**University Village North, Sections 3 & 4 - Revised
PRELIM PLAT PP1510-001**

University Village North, Sections 3 & 4
PRELIMINARY PLAT PP1510-001

DATE OF REVIEW: November 4, 2015

PRELIMINARY PLAT - REVISION 2

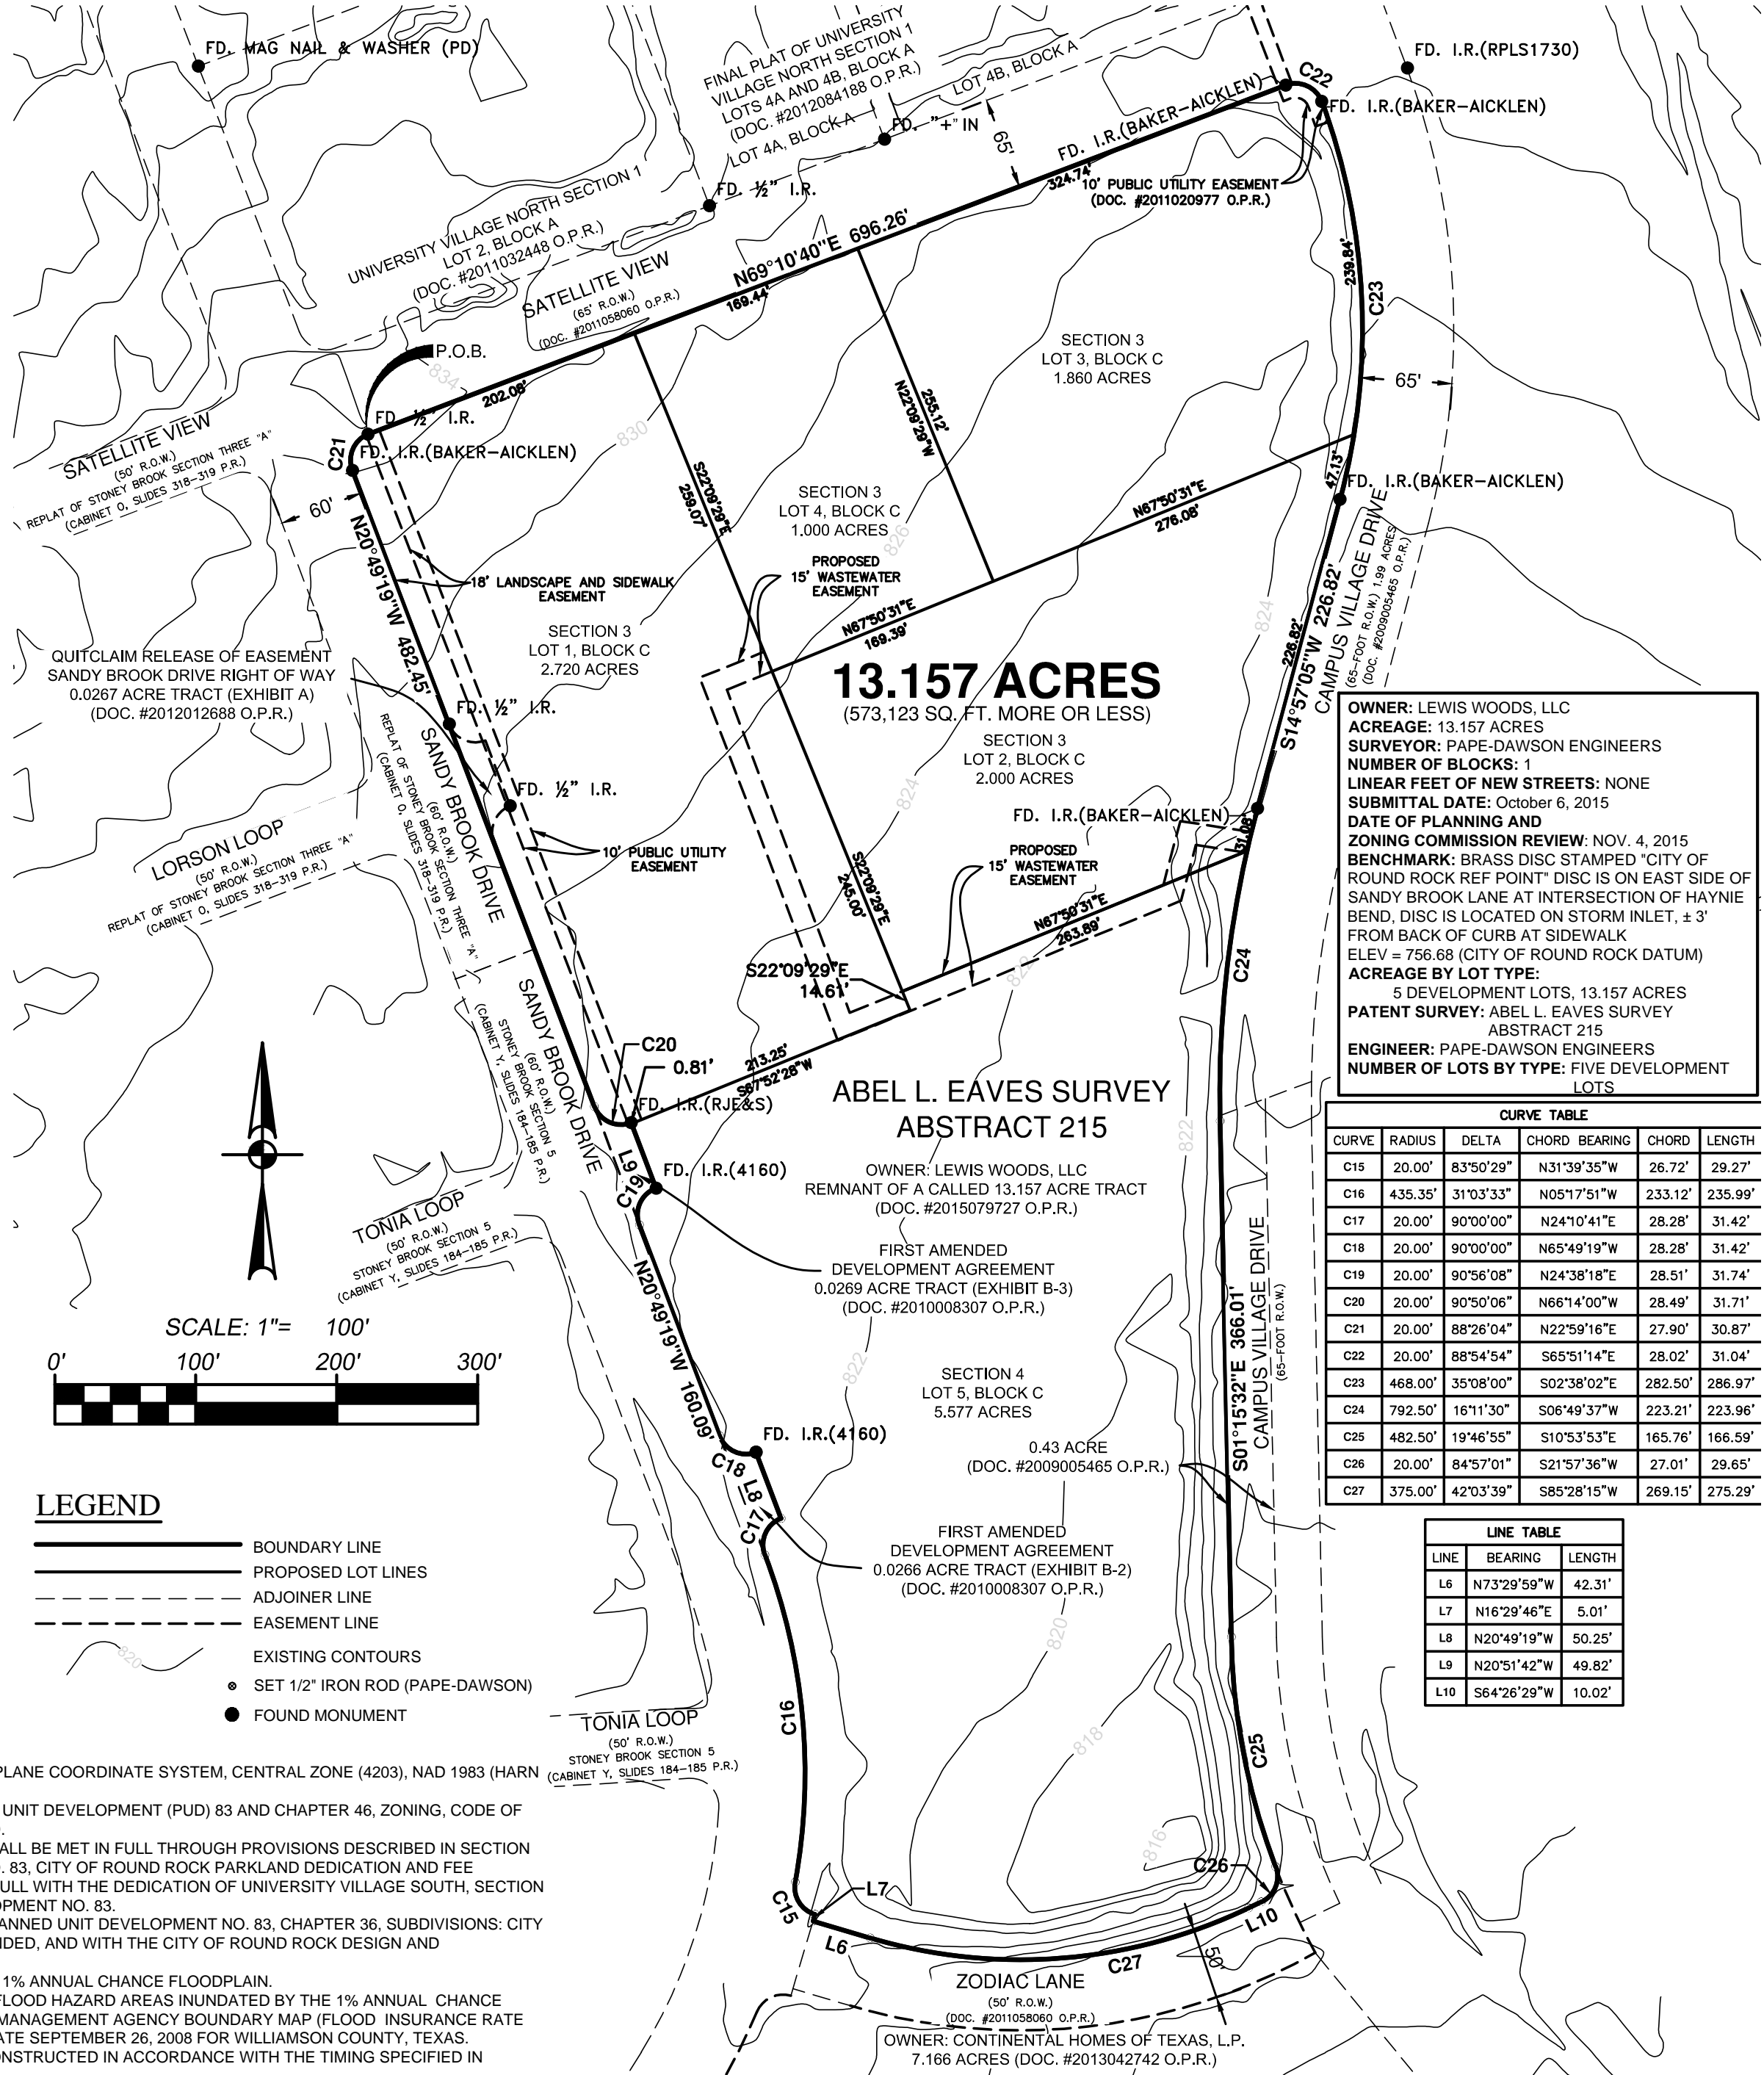
1. Provide vertical datum for the benchmark.
2. Update utility schematic to show services to all lots.
3. Correct typos in the general notes.
4. Remove both stub-outs along Sandy Brook Drive after the quitclaim release of easement has been recorded.
